## **Agreement concerning the International Carriage of Dangerous Goods by Road (ADR)**

### **Draft amendments to annexes A and B of ADR**

#### **Addendum**

This document contains the requested additional list of amendments adopted by the Working Party at its 111th session.

“6.8.3.2.9.6 Safety valve mark

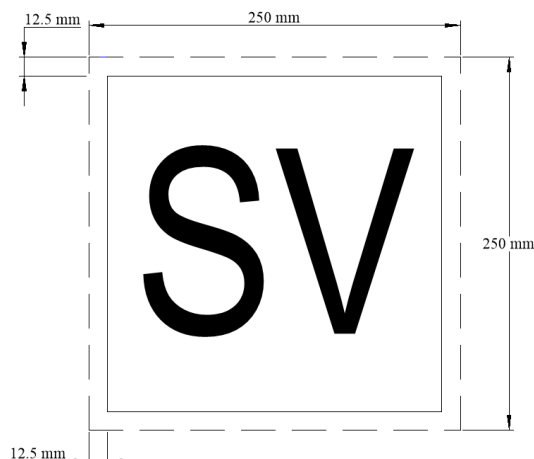
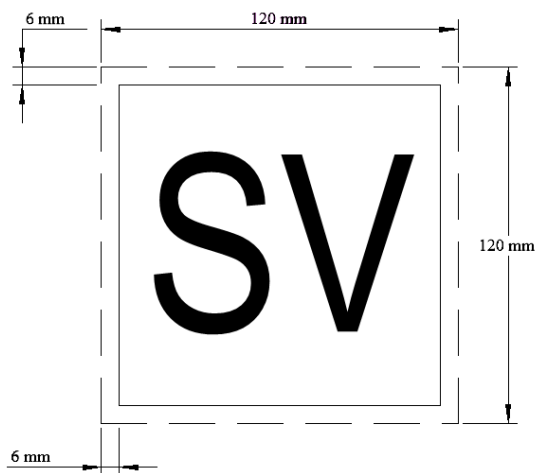
6.8.3.2.9 Insert the following new 6.8.3.2.9.6:

6.8.3.2.9.6.1 Tanks fitted with safety valves in accordance with 6.8.3.2.9.1 to 6.8.3.2.9.5 shall display the mark as set out in 6.8.3.2.9.6.3 to 6.8.3.2.9.6.6.

6.8.3.2.9.6.2 Tanks not fitted with safety valves in accordance with 6.8.3.2.9.1 to 6.8.3.2.9.5 shall not display the mark as set out in 6.8.3.2.9.6.3 to 6.8.3.2.9.6.6.

6.8.3.2.9.6.3 The mark shall consist of a white square with minimum dimensions of 250 mm × 250 mm. The line inside the edge shall be black, parallel and approximately 12.5 mm from the outside of that line to the outside edge of the mark. The

letters "SV" shall be black, a minimum of 120 mm high and have a minimum stroke thickness of 12 mm.

6.8.3.2.9.6.4 For demountable tanks | For tank-containers

with a capacity of not more than 3 000 litres the mark may be reduced in size to not less than 120 mm × 120 mm. The line inside the edge shall be black, parallel and approximately 6 mm from the outside of that line to the outside edge of the mark. The letters "SV" shall be black, a minimum of 60 mm high and have a minimum stroke thickness of 6 mm.

6.8.3.2.9.6.5 The material used shall be weather-resistant and it shall be ensured that the mark is durable. The mark shall not become detached from its mount in the event of 15 minutes' engulfment in fire. It shall remain affixed irrespective of the orientation of the tank.

6.8.3.2.9.6.6 The letters "SV" shall be indelible and shall remain legible after 15 minutes' engulfment in fire.

6.8.3.2.9.6.7 The marks shall be displayed on both sides and the rear of fixed tanks (tank-vehicles) and on both sides and both ends of demountable tanks.

The marks shall be displayed on both sides and both ends of tank-containers. For tank-containers with a capacity of less than 3 000 litres the marks may be displayed either on both sides or on both ends.
